SERVICE TECHNICAL INFORMATION

ONE POINT REPAIR

UTSUNOMIYA, JAN. 20, 1998
REF. NO.: SI-97-063
CUSTOMER RELATIONS & SERVICE DIV.

- MODELS** : HS-JX869/879
- SUBJECT** : Previous recording remains undeleted after the operation of recording - stopping - recording again, at the interrupted point.

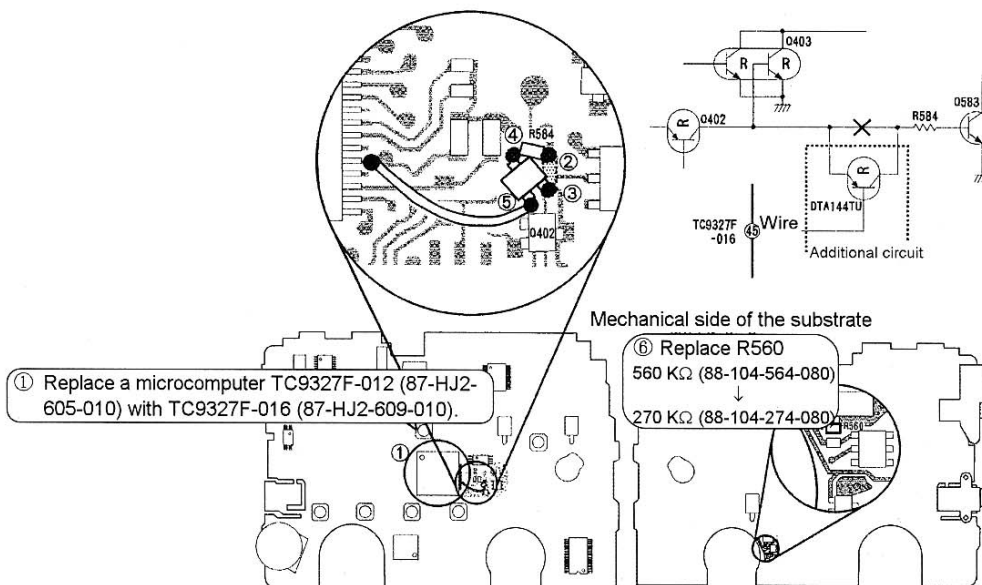
- CONTENTS** : During operation of overwriting on a previously-recorded tape, a device of the above model fails to delete previous recording for approximately 0.7 seconds at the point where recording has been interrupted. The fault occurs during the following operation:
Recording is stopped, and then resumed from the same point.
To solve the problem, take the following actions

- REMEDIES** :
- 1) Replace the microcomputer TC9327F-012 with TC9327F-016 on the main substrate.
(The old and new microcomputers are incompatible with each other.)

- 2) Remove R584 chip resistor on the substrate.
 - 3) Solder the emitter of an externally mounted transistor DTA144TU onto Q402-side land to where R584 was connected before.

- 4) Solder the collector of the externally mounted transistor DTA144TU onto R584. Solder the other side of R584 lead onto the originally connected land. Here, R584 has been turned in 90 degrees.

- 5) Connect the base of the externally mounted transistor DTA144TU to the pin 45 of microcomputer TC9327F using a lead wire.
 - 6) Replace the chip resistor R560 (560K-ohm) on the substrate bottom (mechanical side of the substrate) with a 270K-ohm resistor.
